Architect's Supplemental Instructions

PROJECT: *(name and address)*
57-21113-00 - Rebid Dutchess Stadium
New Left Field Clubhouse, Seating Bowl,
& Restroom Building

ASI INFORMATION:
ASI Number: 008

Date: September 5, 2023

OVERALL FLOOR PLAN, LEVEL 2 - BASE BID
SCALE: 1/8" = 1'-0"

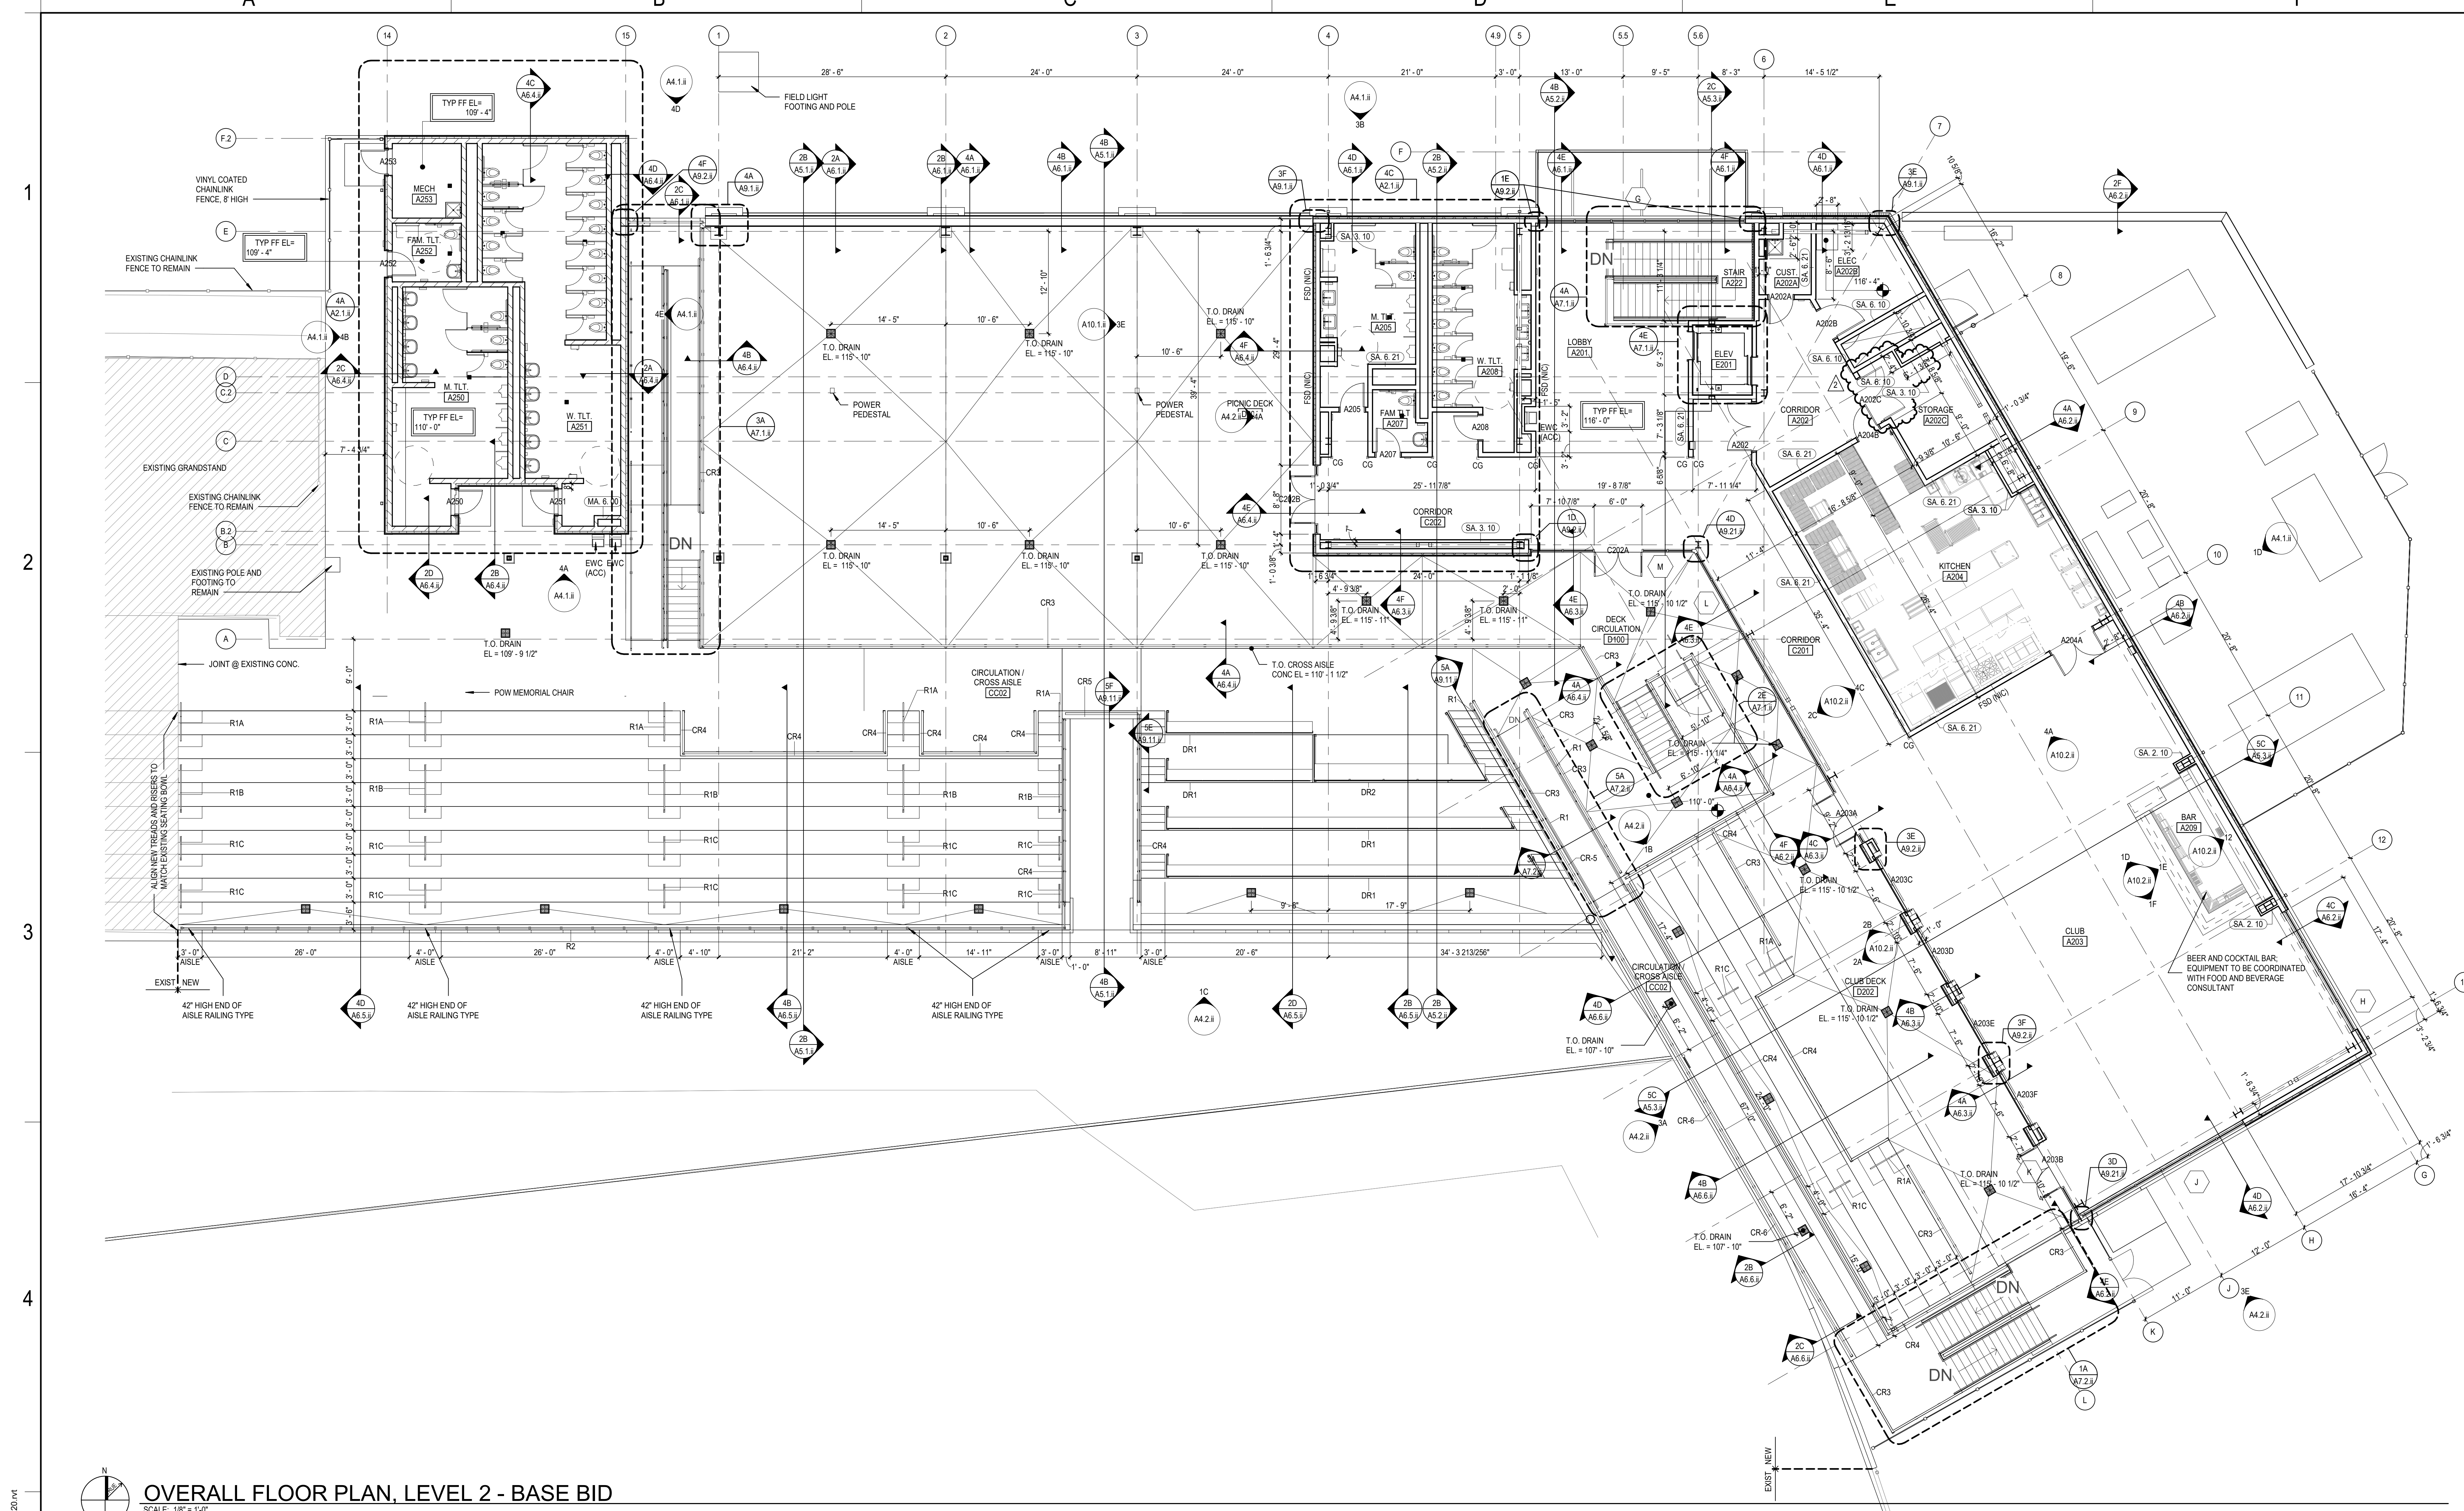
1. Sheet A1.2A.ii - FLOOR PLAN - AREA A - LEVEL 2
 - a. Modifications per the attached sheet.
2. Sheet A3.1A.ii - REFLECTED CEILING PLAN - AREA A - LEVEL 1
 - a. Modifications per the attached sheet.
3. Sheet A3.2A.ii - REFLECTED CEILING PLAN - AREA A - LEVEL 2
 - a. Modifications per the attached sheet.
4. Sheet S1.1.ii - FOUNDATION PLAN
 - a. Modifications per the attached sheet.
5. Sheet S4.2.ii - STRUCTURAL SECTIONS
 - a. Modifications per the attached sheet.
6. Sheet M1.1A.ii - HVAC PLAN - AREA A - LEVEL 1
 - a. Modifications per the attached sheet.
